Access Compliance Report

Public Rights-of-Way

(Curb Ramps)

Intersection ID: 11707	Main Street: N_GRAHAM_ST	Cross Street: W_6TH_ST	Location: N
ADA ID: EFAD2BD1118B	Ramp Type: Perp	Initial Pass/Fail: Fail	Overall Compliance: No
Severity Score: 13.75			
Codes/Mitigation Info/Possible Solution		Field Measurements/Component Compliance

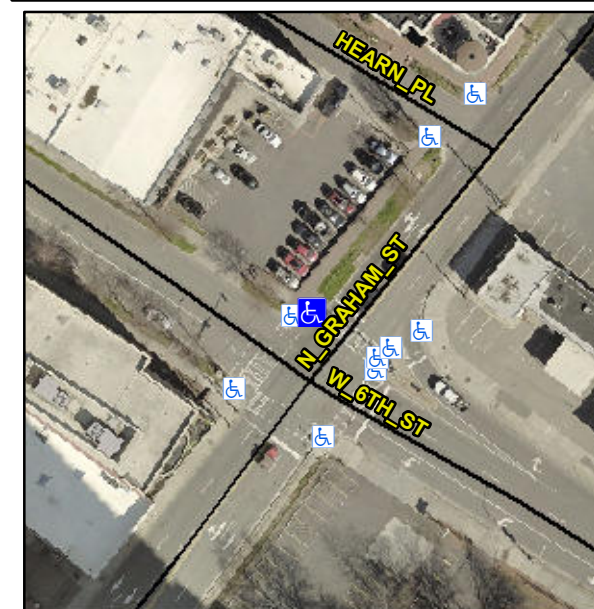
Not Found, R304.2.2, R304.5.3

Compliance	Description	Data	Compliance	Description	Data
N/A	Ramp Length (in)	84.0	No	Ramp Slope (%)	11.1
Yes	Ramp Width (in)	49.0	No	Ramp XSlope (%)	2.8
N/A	Flare Type LT	N/A	N/A	Flare Type RT	N/A
N/A	Flare Slope LT (%)	N/A	N/A	Flare Slope RT (%)	N/A
N/A	Flare Traversable LT?	N/A	N/A	Flare Traversable RT?	N/A
N/A	Landing Length (in)	N/A	N/A	DWS Provided?	N/A
N/A	Landing Width (in)	N/A	N/A	DWS Contrast?	N/A
N/A	Landing Slope (%)	N/A	N/A	DWS Length (in)	N/A
N/A	Landing X Slope (%)	N/A	N/A	DWS Full Width?	N/A
N/A	Landing Curb? (Y/N)	N/A	N/A	DWS Offset (in)	N/A
N/A	Shared Landing?	N/A			
N/A	Gutter Ponding?	N/A	N/A	Gutter Slope (%)	N/A
N/A	Gutter Lip Ht (in)	N/A	N/A	Gutter X Slope (%)	N/A
N/A	Painted X Walk1?	Yes	N/A	Painted X Walk2?	N/A
	X Walk 1 Direction	To SE		X Walk 2 Direction	N/A
N/A	X Walk 1 Width (in)	109.0	N/A	X Walk 2 Width (in)	N/A
	X Walk 1 Slope (%)	4.3		X Walk 2 Slope (%)	N/A
	X Walk 1 X Slope (%)	1.8		X Walk 2 X Slope (%)	N/A

Remove & Replace Entire Ramp.
